**Report to
Rapport au:**

**Built Heritage Sub-Committee / Sous-comité du patrimoine bâti
February 11, 2020 / 11 février 2020**

File Number: ACS2020-PIE-RHU-0005

SUBJECT: Application to Alter two heritage properties, 35-37 William Street and 41-41 1/2 William Street, designated under Part V of the *Ontario Heritage Act* and located in the ByWard Market Heritage Conservation District, according to plans by KWC Architects, received in December 2019

Document 7 – Elevations, 35-37 William Street

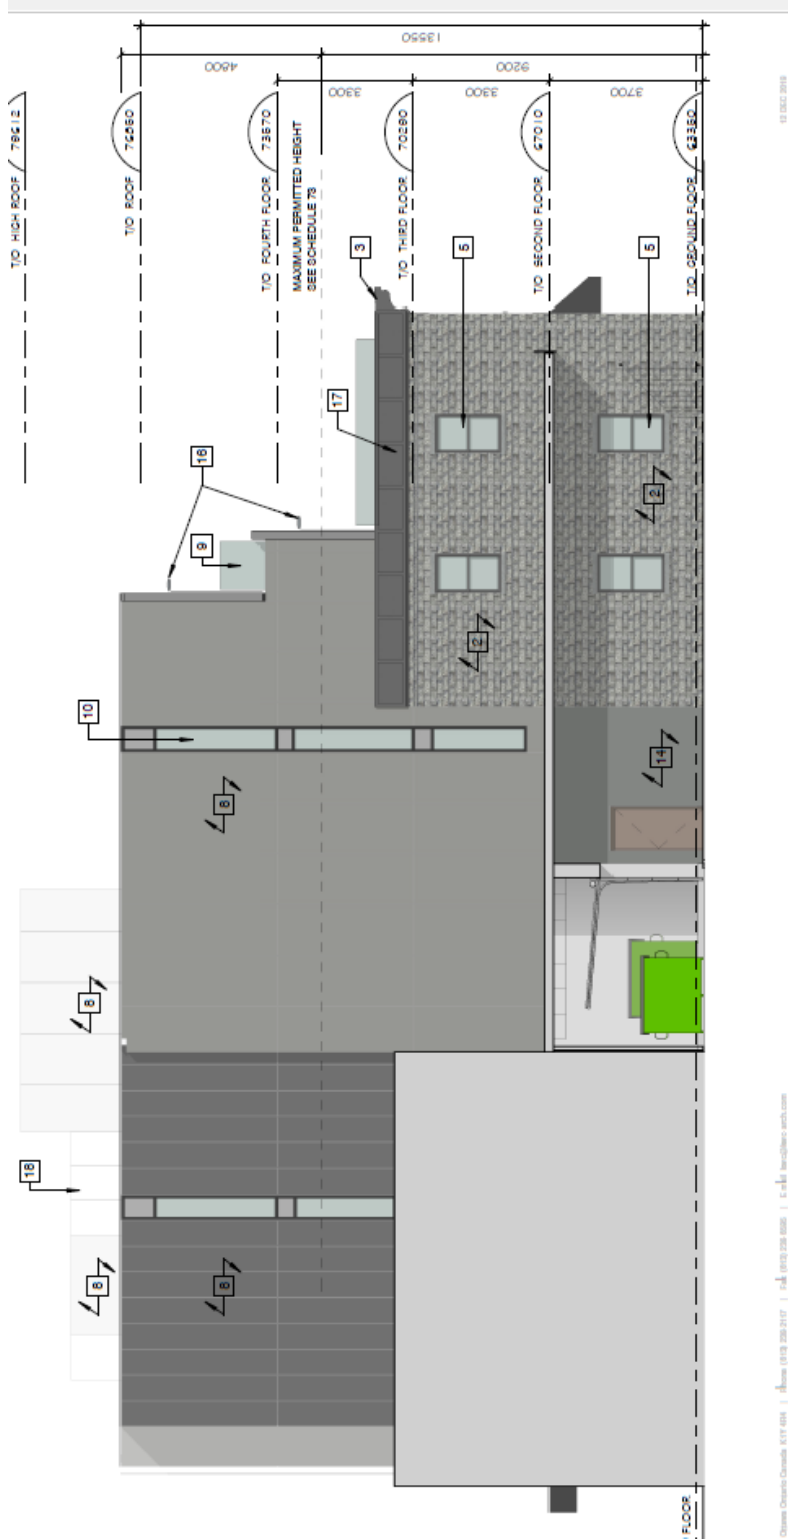
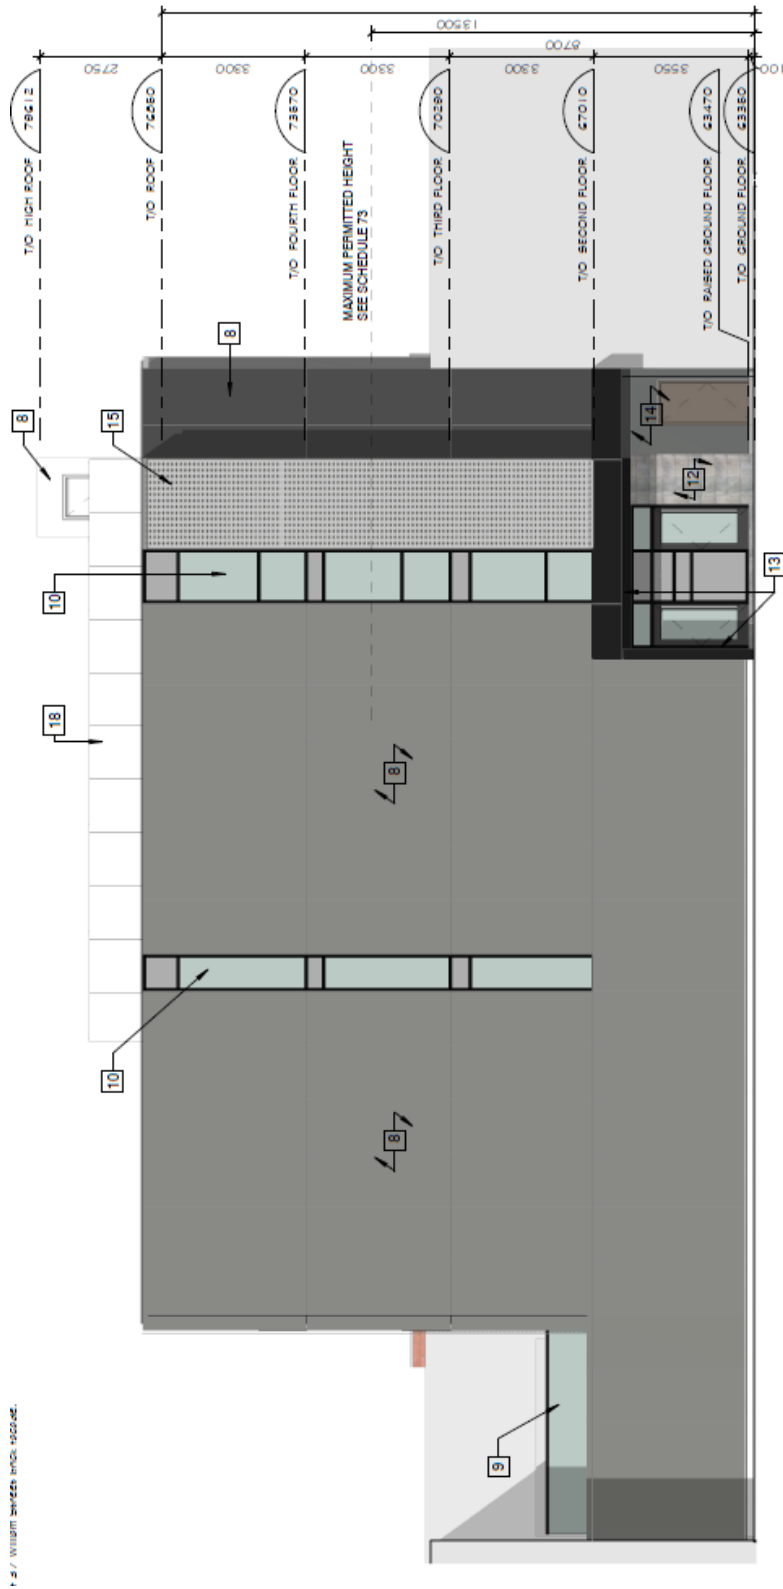
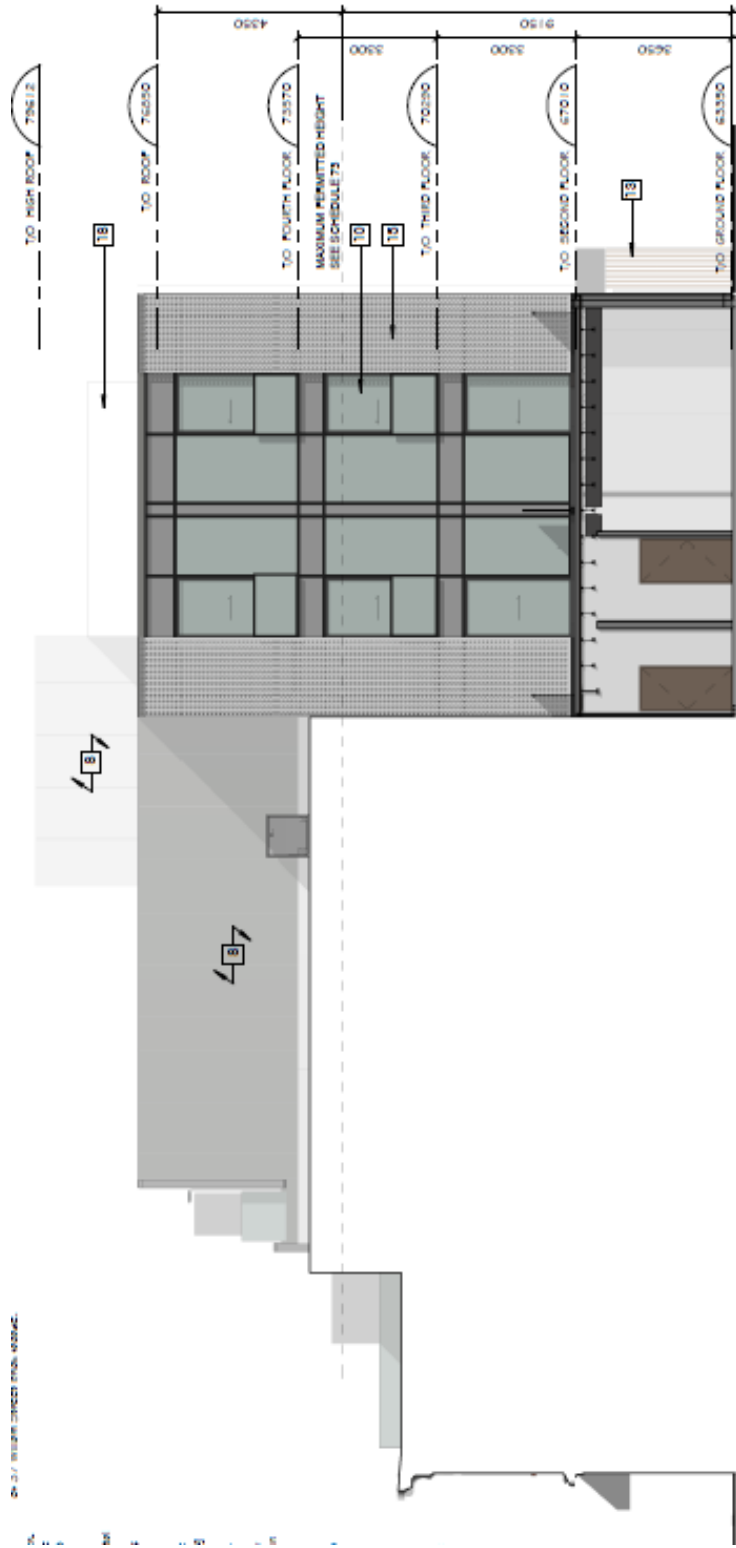
"I am supportive of the proposal for the alteration of the fire-damaged buildings, 35-37 William Street. I am happy to see the project moving forward, and, with respect to the heritage and the character of the ByWard Market. With regard to specific plans, I would like to see some added visual relief to the windowless walls (facing east and west) as well as set back the proposed balcony railing on the third floor from the William Street façade.

Additionally, I would like to add windows on the first floor of the east façade, to break up the hard surface and add light, this could be in the form of high horizontal windows. I would also like to ensure roof-top projections are located in a spot to minimize impact to the streetscape and add some kind of detail in design to add a visual interest to the large, blank wall on the west facing wall."
